HDS Furnace PR-175169 — Change Order Summary

Cenovus Lima, OH · Job USA26046 · Quotation DSP#26013 · 25 September 18:00 – 27 September 13:00, 2026 · 4 shifts · Service receipts 8417–8421

Shift timeline

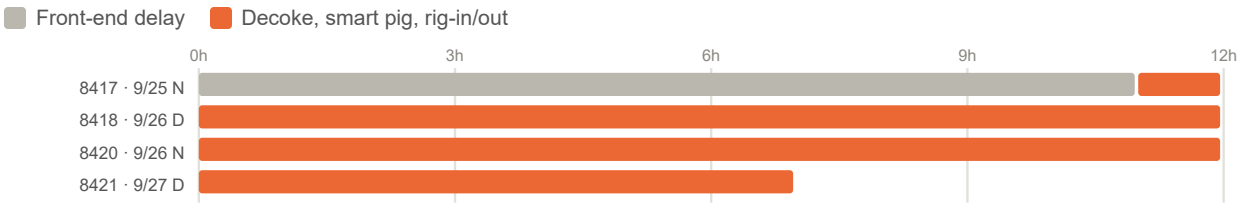
The crew and pumping unit arrived at the HDS at the start of night shift on 25 September, straight from the Crude. Pigging could not begin until the water connection was made and the launchers were installed. The 3" fill hose had to be carried over the road on a hose bridge, and the permit to pig was issued at 04:00. Eleven hours of that shift were lost to the delay.

Once the delay cleared, the heater was decoked, smart pigged and rigged out in 32 hours against the 36 quoted. Both circuits ran together, so the quoted rig-over was not needed.

SHIFT	RECEIPT	HOURS	DELAY	WORK
25 Sep night	8417	12	11	1
26 Sep day	8418	12	–	12
26 Sep night	8420	12	–	12
27 Sep day	8421	7	–	7
Total		**43**	**11**	**32**
